DESIGN REVIEW/CERTIFICATE OF APPROPRIATENESS

Project/Property Address or Location:	Project Name/Business Name			
1365 STONERIDGE DR	KROGER N-871			
Parcel ID No.(s): Zoning Designation:	CC-7 Mg Mg Total Acreage:			
	D SHOPPING CENTER 10.45			
Please check all that apply:				
SITE PLAN LANDSCAPING BUILDING	Univ application			
	to Code Chapter 1150, Otda Gabanna			
Project Description:				
Adding a small addition under the existing canopy	of the existing Kroger store. New stone/ brick will			
match the existing.				
APPLICANT Name -do not use a business name:	Applicant Address:			
Nathan Fields	300 Spruce St., Suite 300			
Applicant E-mail:	Applicant Phone No.:			
nfields@moodynolan.com	614-280-9737			
BUSINESS Name (if applicable):				
Moody Nolan, Inc.				
ADDITIONAL CONTACTS Please List Primary Contact for Corresp				
Name(s):	Contact Information (phone no./email):			
Nathan Fields	nfields@moodynolan.com, 614-280-9737			
Todd Dove	(primary)			
	tdove@moodynolan.com, 614-461-4664

RE: Project 1365 Stoneridge Design Review Comment Letter

PLANNING STAFF REPORT

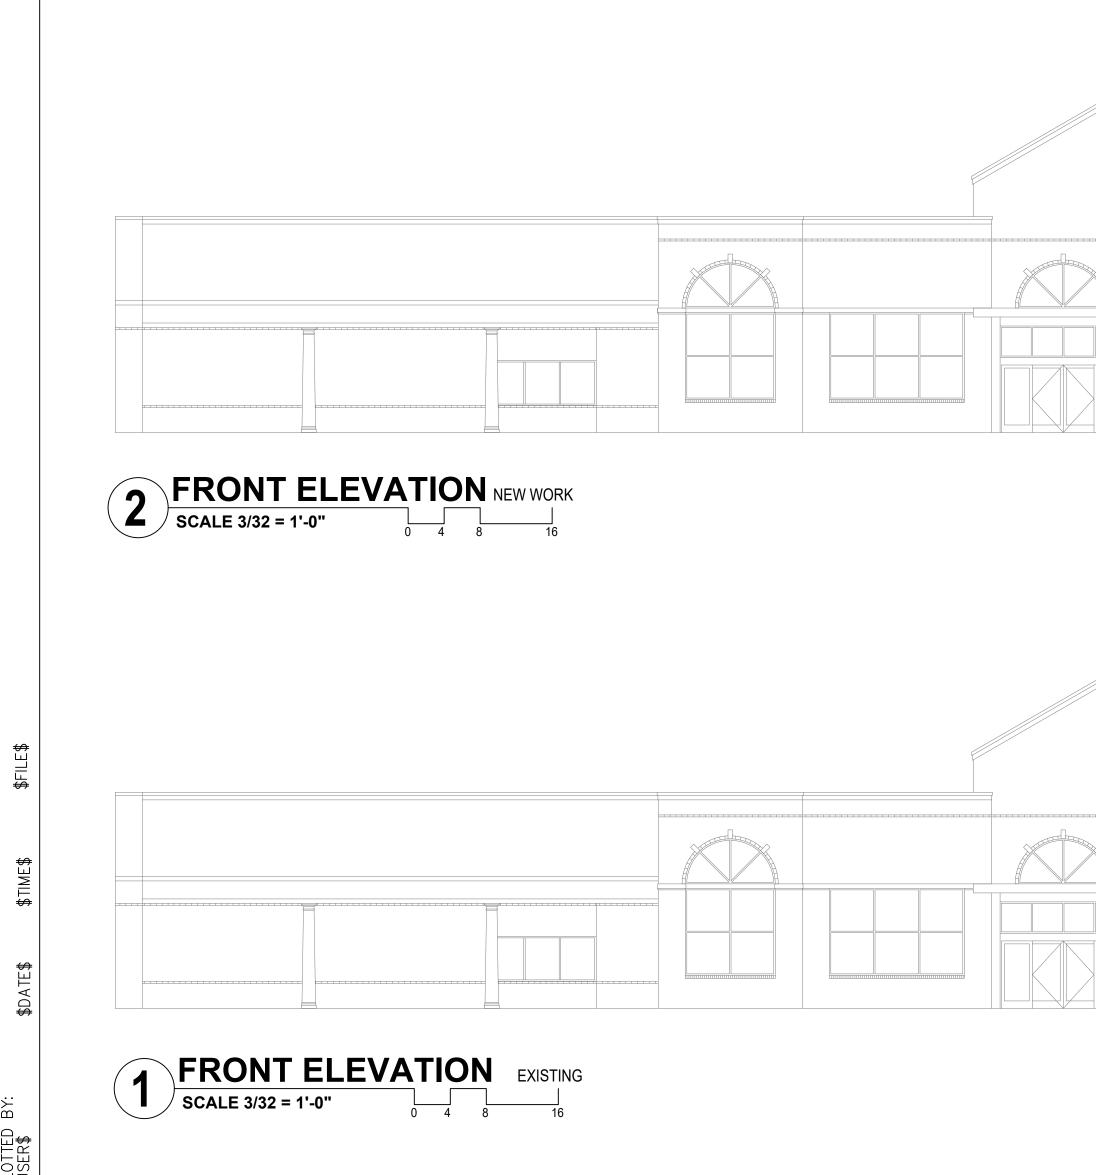
- 1. The fire division has no objection to the Clicklist addition to the front of the Kroger Stoneridge. The fire lane and driveway in front of the store are existing and the plans show no modification of the existing drive. There is no issue with the Clicklist parking where it is situated.
- 2. Any modifications to the building or fire protection systems will be addressed when building and fire protection system plans are submitted for construction review.

Applicant requests permission for minor revisions to the parking lot and revisions to the front façade for the Kroger located at Stoneridge Plaza. The changes are very similar to those changes recently approved for the Kroger Market Plaza at Hunters Ridge. Changes include new parking area for click list shoppers, new door and new awning.

Staff recommends approval of this request. The revisions meet code standards for parking space size and number. The façade changes are minor in nature and the design and materials will match that of the existing building.
